Boys & Girls Clubs of Central Texas

ADDENDUM NO. 1

McLaurin-Boyd Campus Phase 2 Expansion –
Great Futures 2025 Project - **REBID**
ARPA 04

Date: March 21, 2023

1 Mechanical plan - gym area
Scale: 3/16"=1'-0"

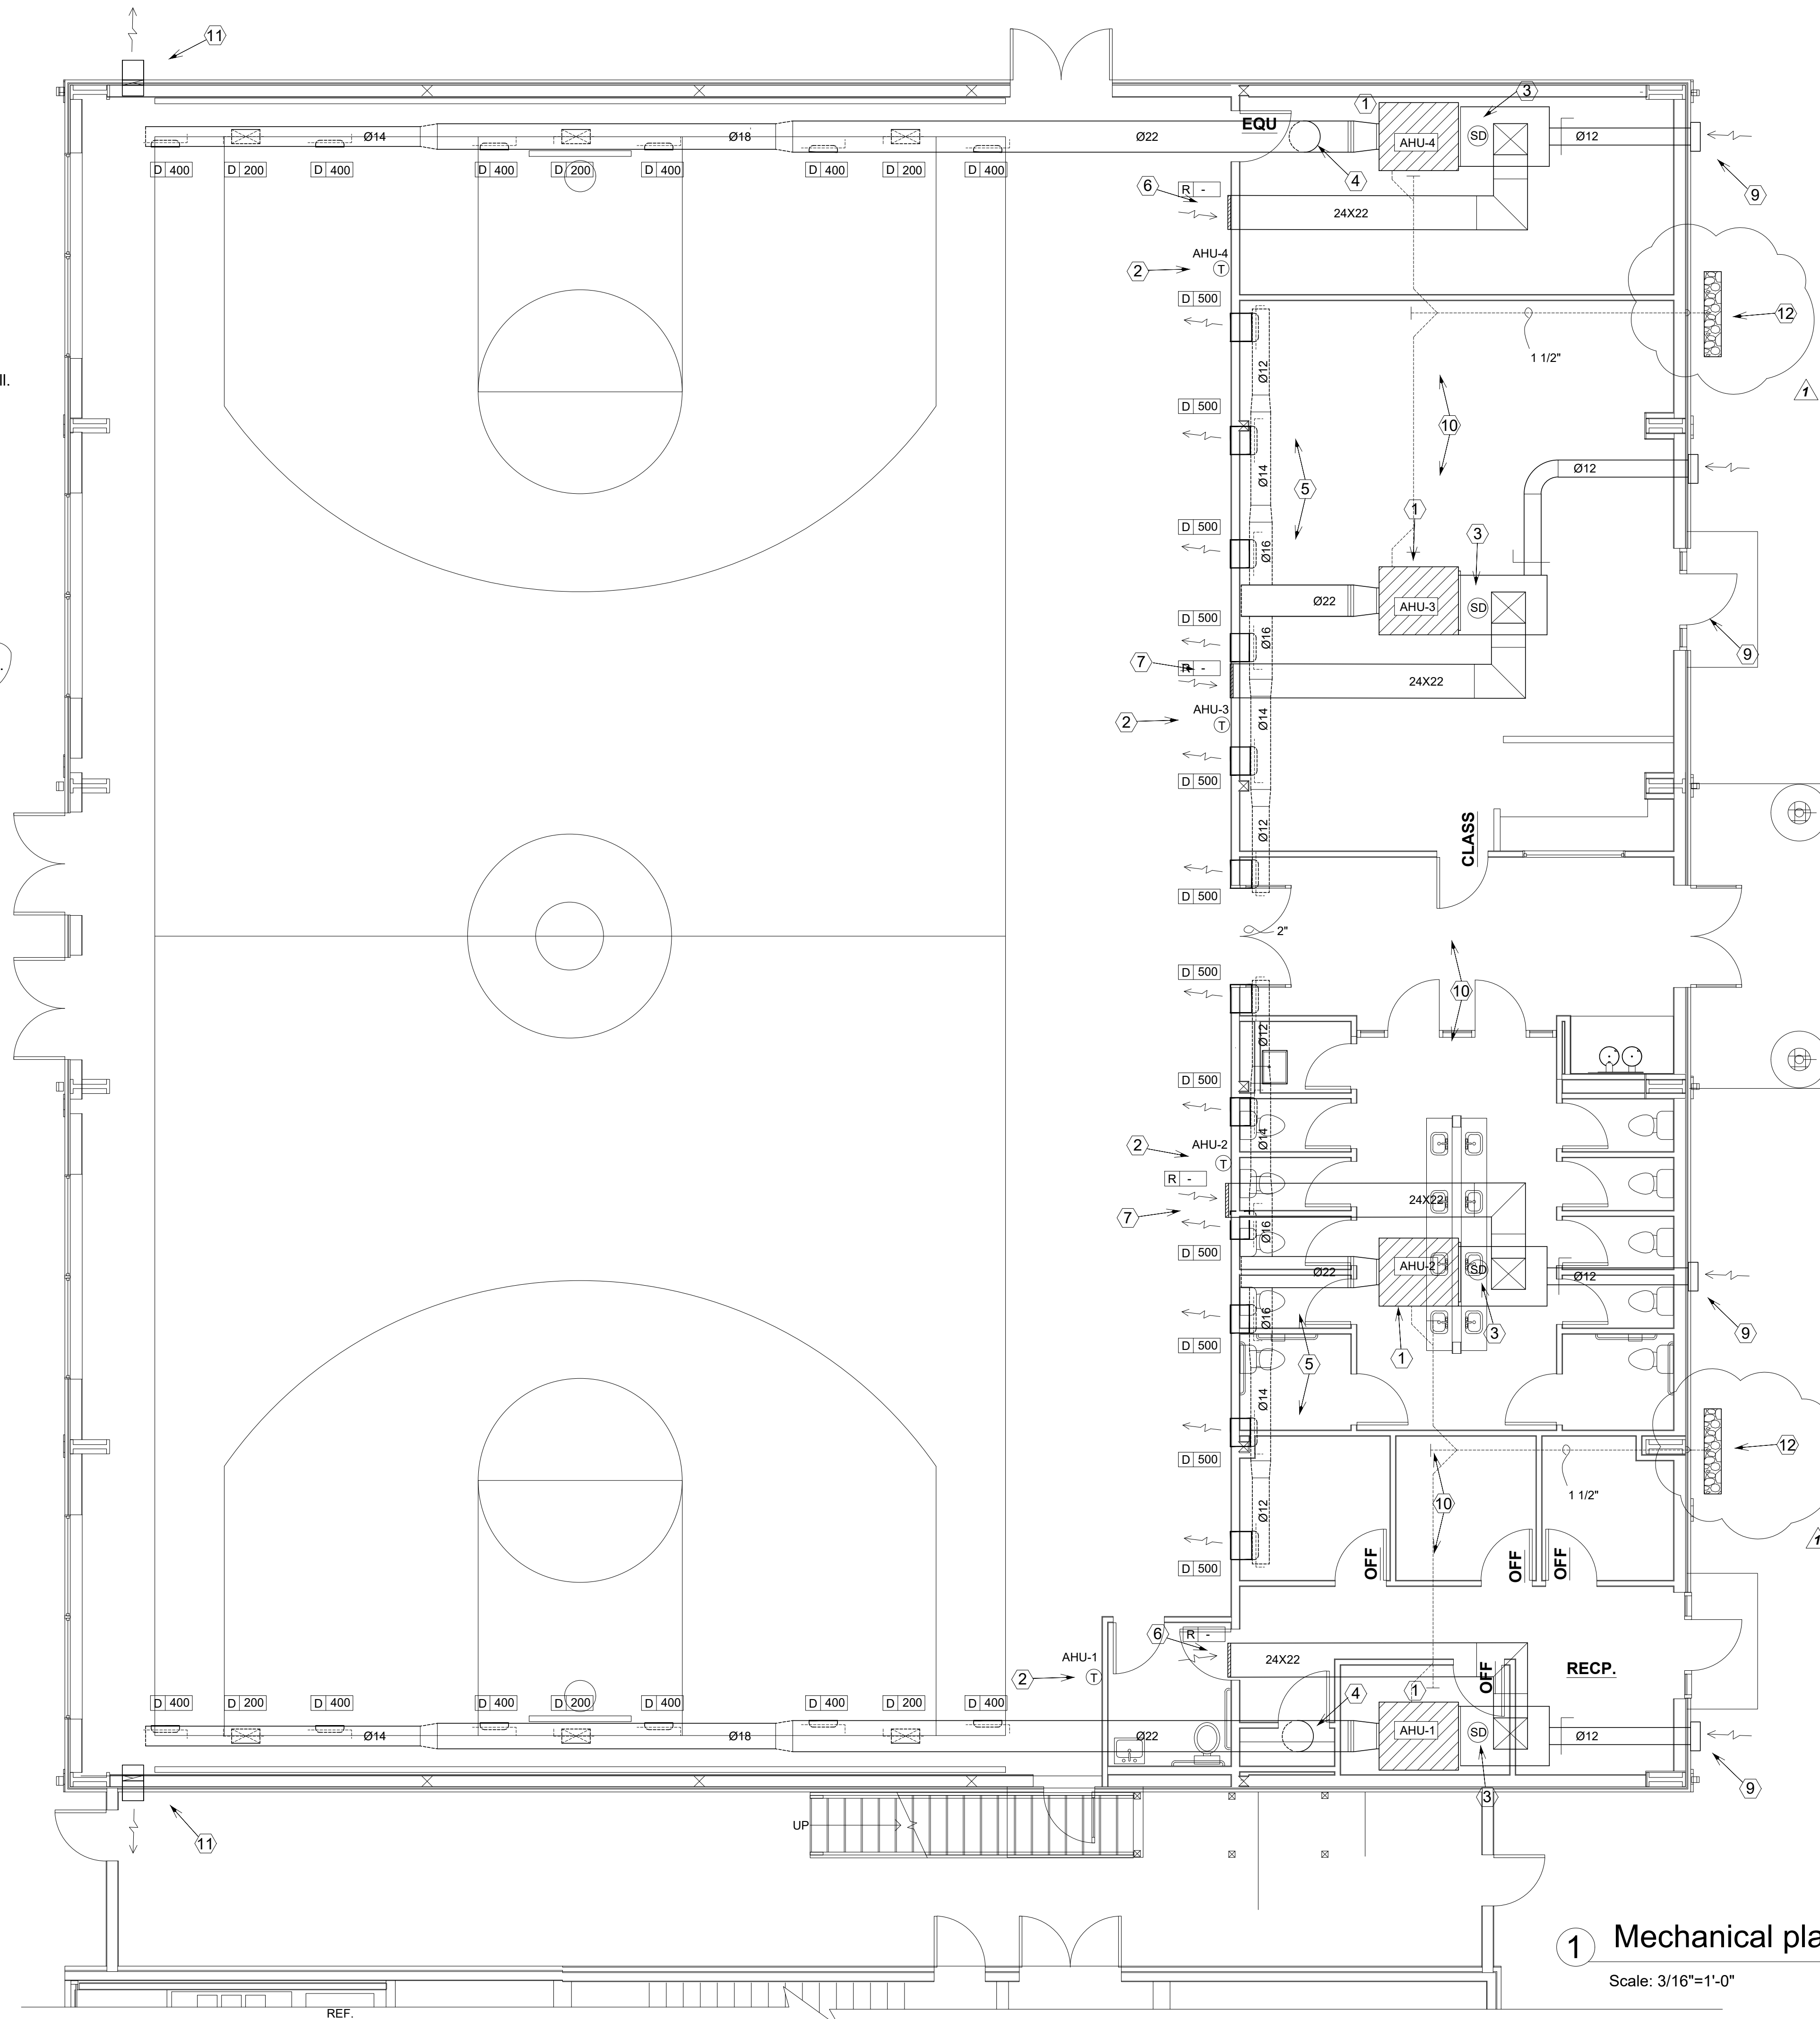
1. Mechanical Plan Page – Gym Area HVAC duct... What is the size of the duct at the perimeter of the building?...the horizontal ducts are marked but nothing is marked for the perimeter duct size.

See MEP addendum page m-1, m-2 and m-3.

- ④ Route supply air ducts from "AHU-1" and "AHU-4" up near roof deck then penetrate wall and run duct straight to other side of field.
- ⑤ Route supply air ducts from "AHU-2" and "AHU-3" parallel wall and penetrate diffusers through wall. Install wall registers at 11 feet above floor.
